UNITED STATES PATENT AND TRADEMARK OFFICE

Office Action Summary	Application No. 10/596,843	Applicant(s) TANAKA, HIDEO	
	Examiner LUCY P. CHIEN	Art Unit 2871

DETAILED ACTION

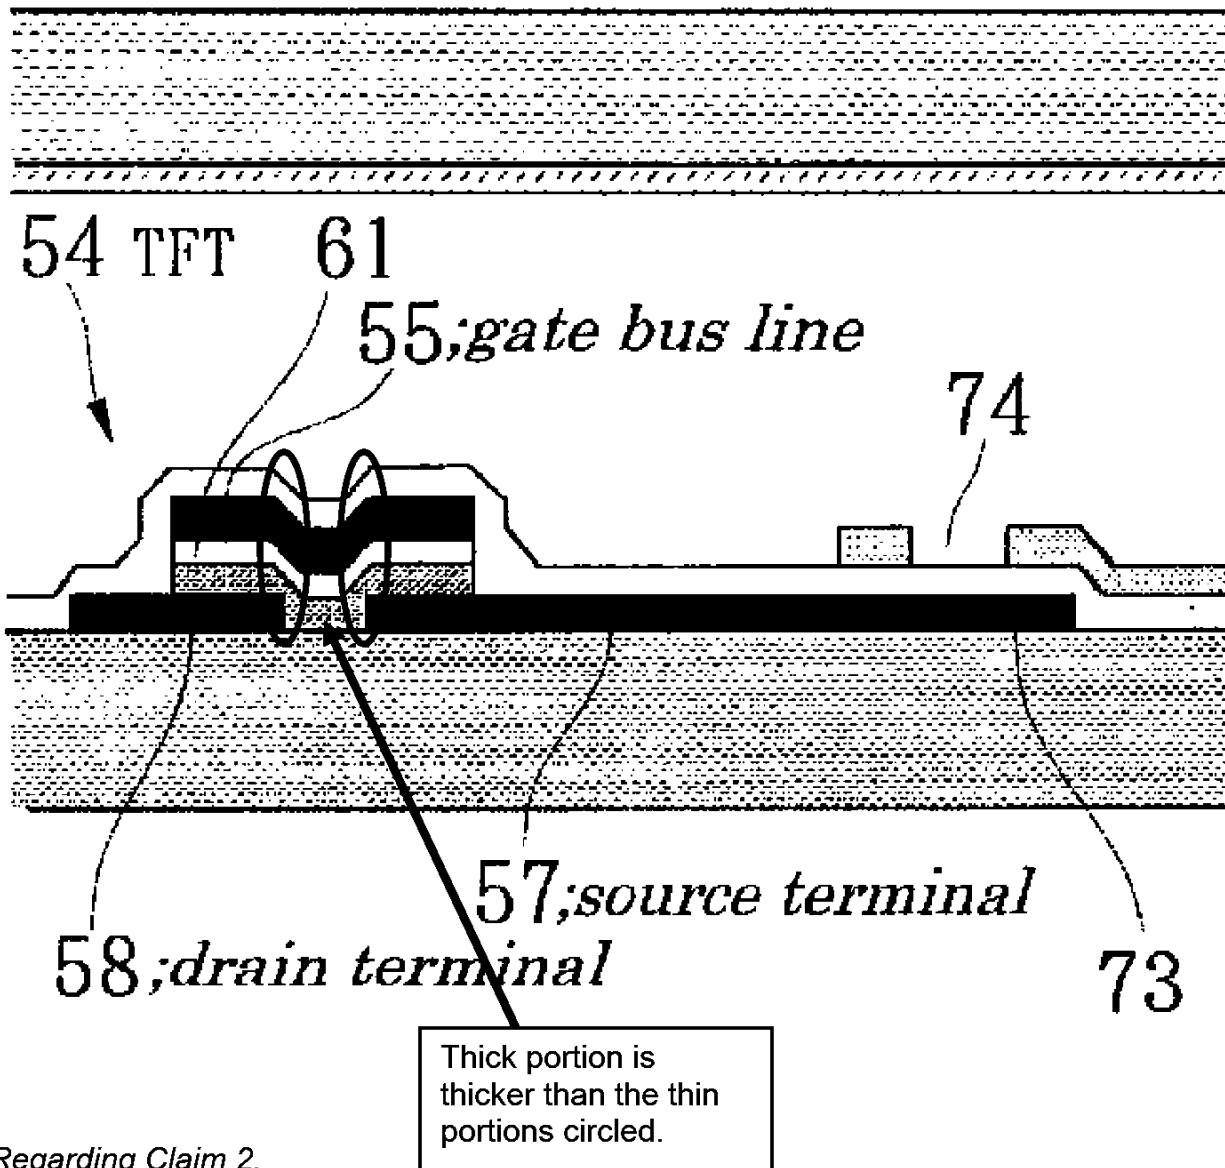
Suzuki et al discloses (Fig. 17, Fig. 18) a source electrode (57) and a drain electrode (58) formed on an insulating substrate (11) a gate insulating film (61) having a relatively thin film portion (circled below) partially on said source electrode (57) and said drain electrode (58) and a relatively thick film portion (with respect to the thin portions circled below) between said source electrode and said drain electrode (shown below); and a gate bus layer (55) formed on said gate insulating film (61) including at least said thin film portion, wherein an MIM (Column 29, rows 50-56) structure is configured by

said source electrode, said drain electrode, said gate insulating film in said thin film portion and said gate bus layer.

Suzuki et al does not disclose an interlayer insulating film between the substrate and the source and drain electrode.
